Comment # and Topic	Comment	Response																		
1 – Delineation	<p>Please provide a map showing all of the sample points taken for the wetlands delineation, including the paired sample points taken on either side of the delineated boundaries. Please include an explanation of the surface features used to draw the boundaries and any other technical work that was performed for this delineation.</p>	<p>Please see the enclosed <i>Updated Jurisdictional Delineation Report</i> for all observation locations within the coastal zone.</p> <p>The limits of the jurisdictional areas depicted in the enclosed <i>Updated Jurisdictional Delineation Report</i> are based upon the vegetation boundaries visible on aerial photography and confirmed in some locations using GPS based on the presence of hydrophytic plant communities. Soil pit data was not collected at this time as a result of restrictions on sampling on the Marine Corps property.</p>

Attachments

PROPOSED CONSTRUCTION AT SAN ONOFRE CREEK

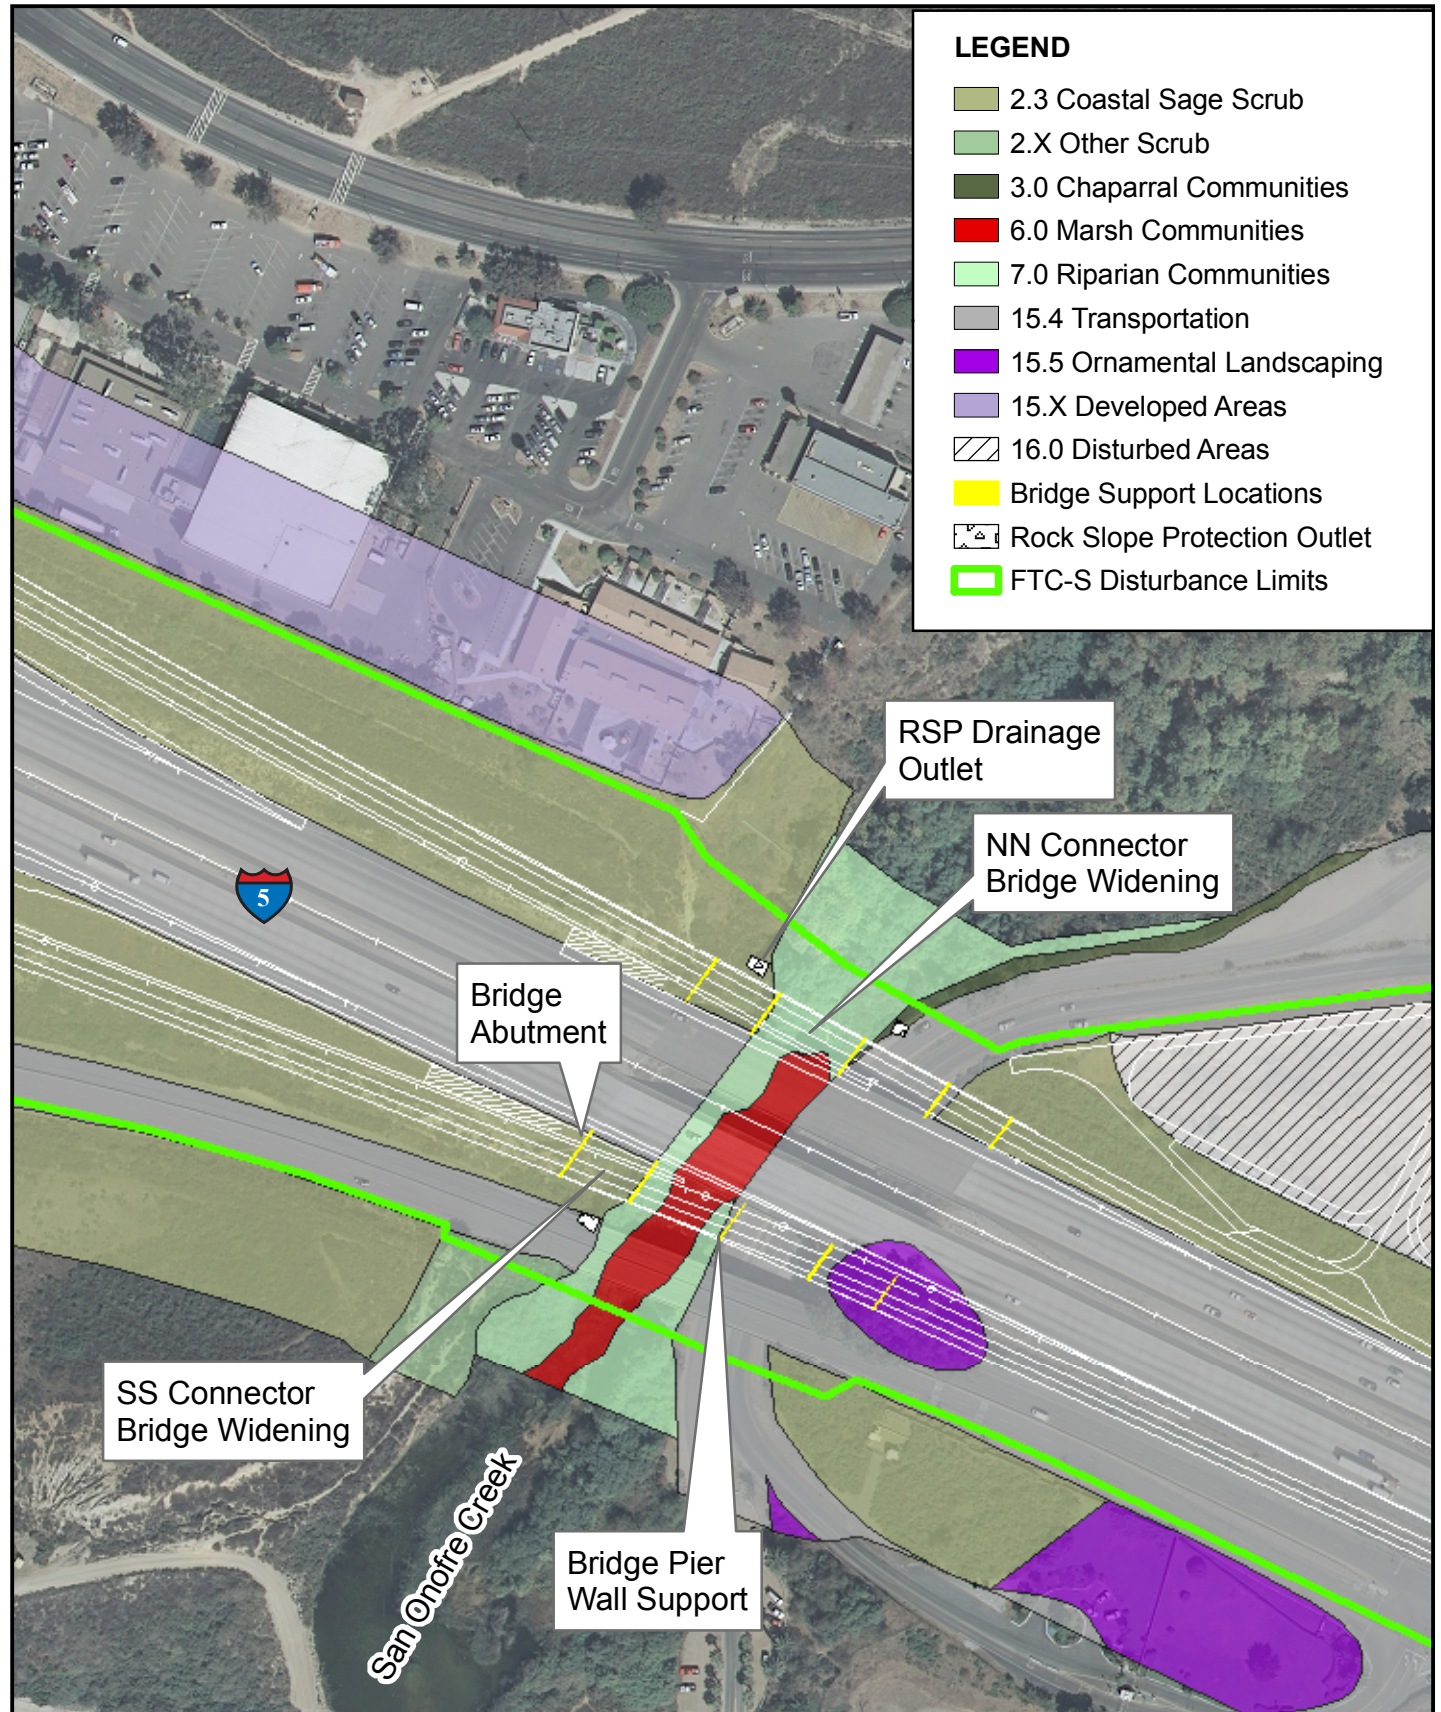
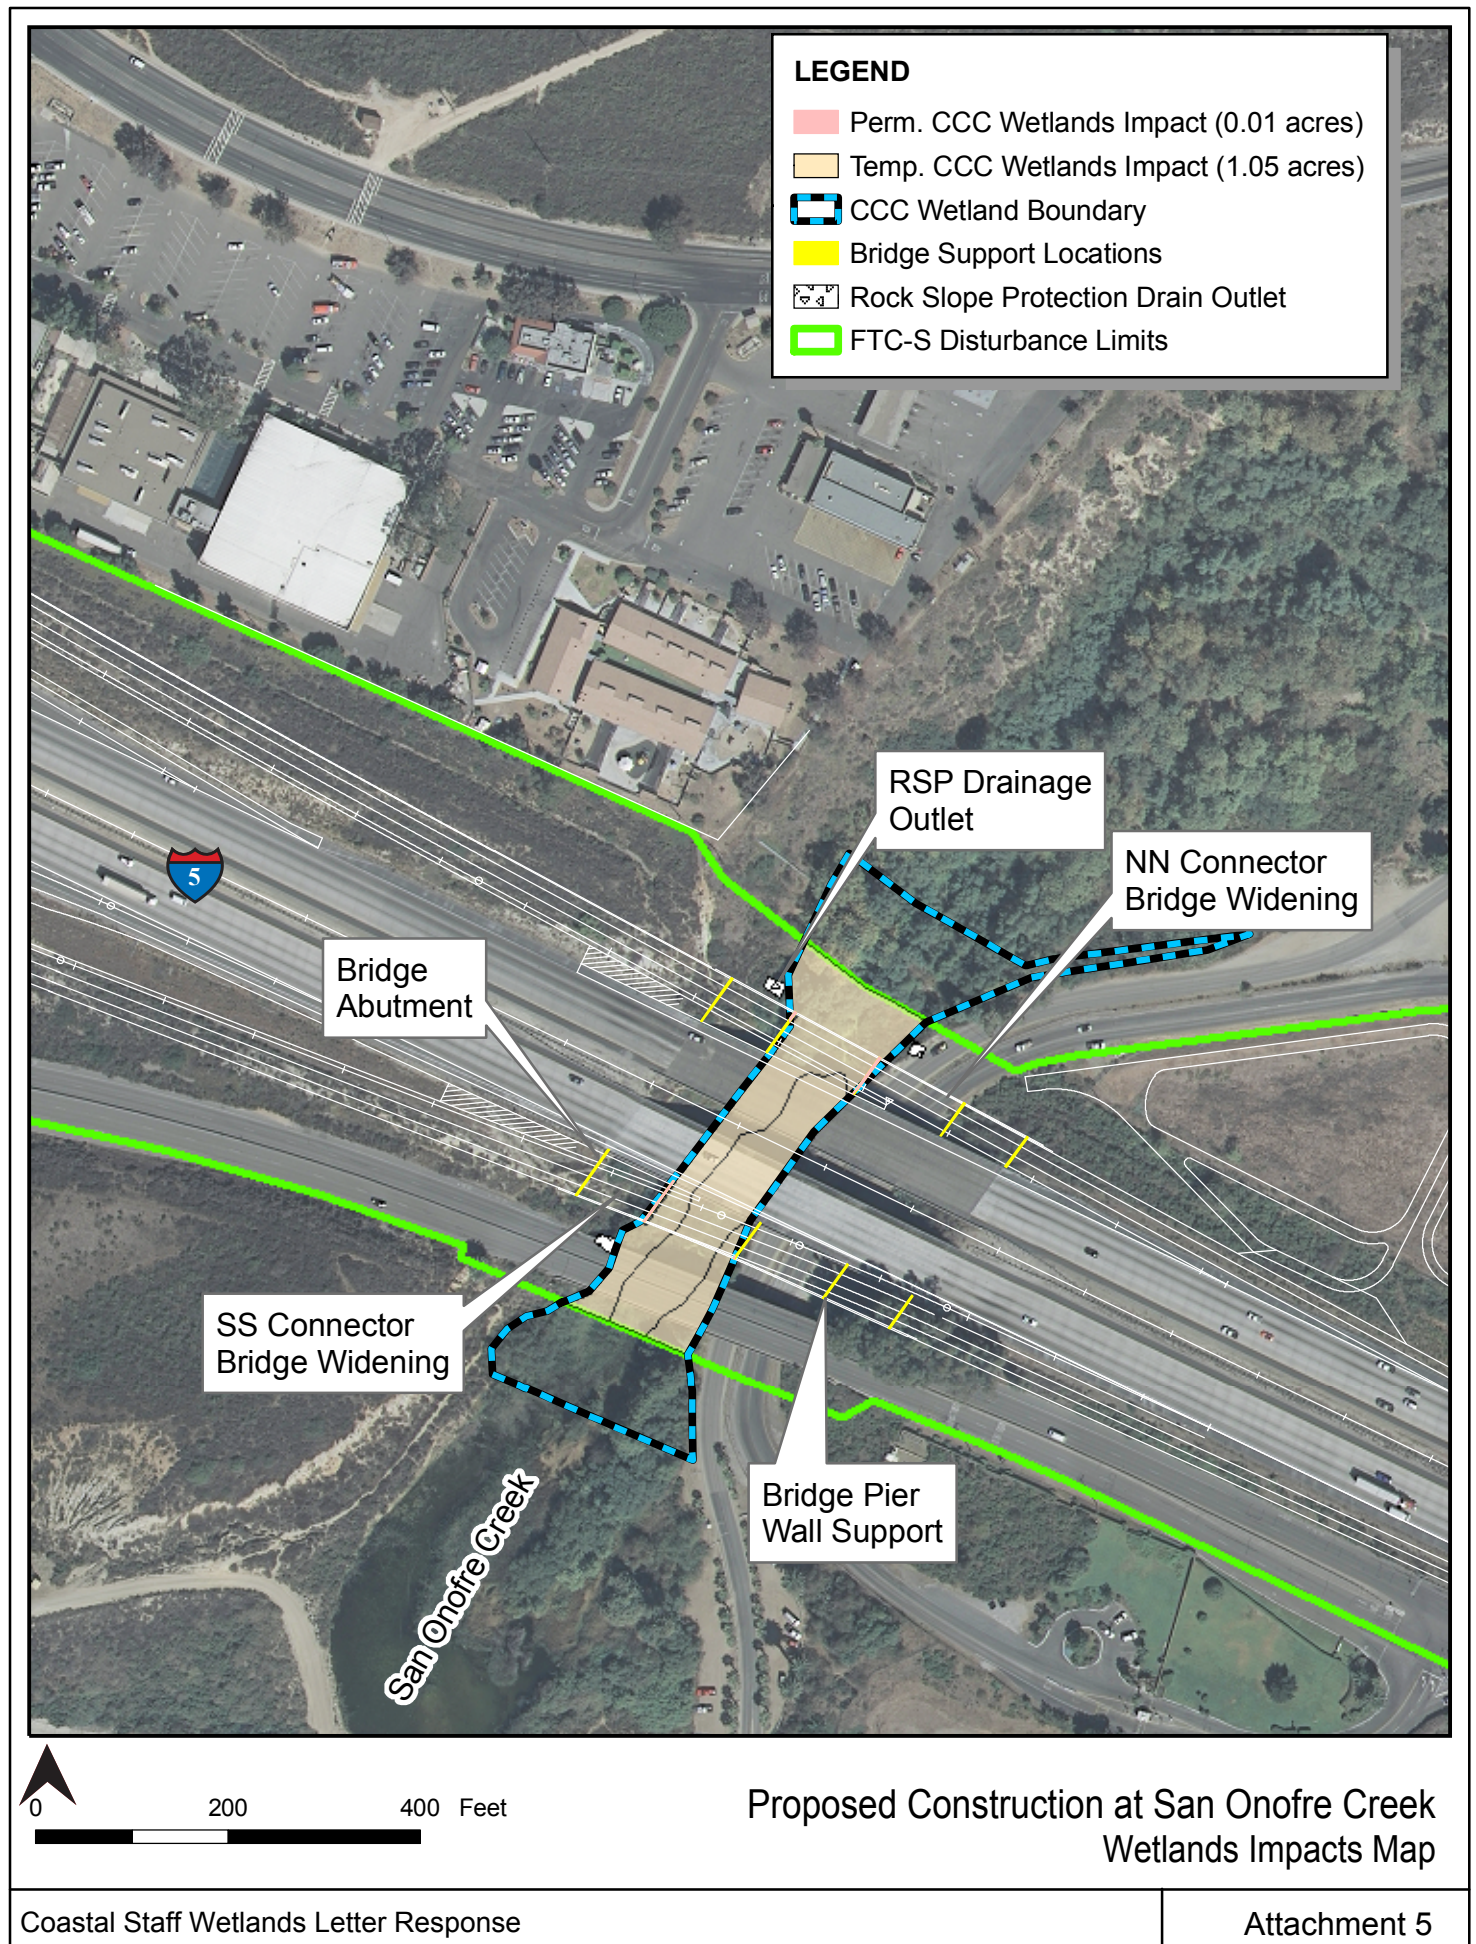
8 – San Onofre Creek	<p>San Onofre Creek- exactly what type of construction is proposed here (p.42)? Is it only widening the bridge supports? What else is involved in the construction of the proposed bridge widening here? Please provide a map that shows what type of construction is proposed at San Onofre Creek, a description of these structures, the vegetation mapped* in and around the creek, the wetland delineations, and the permanent and temporary impacts to wetlands.</p> <p>* Please use a standardized vegetation classification system.</p>	<p>Please see <i>Attachment 5: Proposed Construction at San Onofre Creek</i> for maps of construction type and location, vegetation, and wetlands impacts.</p> <p>At San Onofre Creek, the FTC-S project includes widening of the two existing I-5 bridges (northbound and southbound). The existing structures are four-span continuous cast-in-place reinforced concrete box girder structures. These structures are 354 feet long, and the superstructure is 68.0 feet wide and 5.5 feet deep for both bridges.</p> <p>The two I-5 bridges will be widened to accommodate the I-5/SR 241 direct northbound and southbound connectors. The three existing piers of each bridge will be lengthened. The details of this widening are described below:</p> <p><i>Original Bridge Structures.</i> The existing I-5 San Onofre Creek Bridge is made up of two separate cast-in-place reinforced concrete box girder structures, carrying the northbound and southbound I-5 traffic, respectively. The original structures were constructed in 1968 and are supported on seat type abutments and pier walls that are 2 feet thick. The existing foundation system consists of driven steel piles. The existing bridge superstructure and piers will be widened to accommodate the construction of the new connector ramps.</p> <p><i>Bridge Widening.</i> The proposed new construction will include widening the existing bridge superstructure utilizing cast-in-place reinforced concrete box girders to accommodate the geometric requirements for the northbound and southbound connectors to and from SR-241. The proposed widening will match existing grade and cross slopes. Due to the roadway geometry, the widenings on the outside of the San Onofre Creek Bridges are variable widths. The northbound structure will be widened by an additional 38 to 55 feet. The southbound structure will be widened by an additional 41 to 58 feet. The widened portion of the bridge will be supported on 2 feet thick pier walls that match the existing bridge supports. The pier walls will be founded on 36-inch diameter CIDH concrete piles. All or part of four of the pier walls are located in Coastal Commission wetlands.</p> <p>Falsework will be temporarily erected in San Onofre Creek to facilitate construction of the bridge widening. The falsework will consist of temporary bents and steel pipe supports installed to form the bridge soffit and stems. After the concrete has been poured and cured and the bridge pre-stressed, the falsework will be removed from the site, leaving the concrete bridge structure.</p> <p>Scour could potentially be a concern for the existing San Onofre Creek Bridge. If scour is determined to be a problem, the existing bridge foundations would need to be strengthened to minimize collapse potential. If it is determined that scour is not a concern, then the area identified in <i>Attachment 4</i> as temporary wetlands impact area could be reduced under the existing I-5 bridge structures.</p>
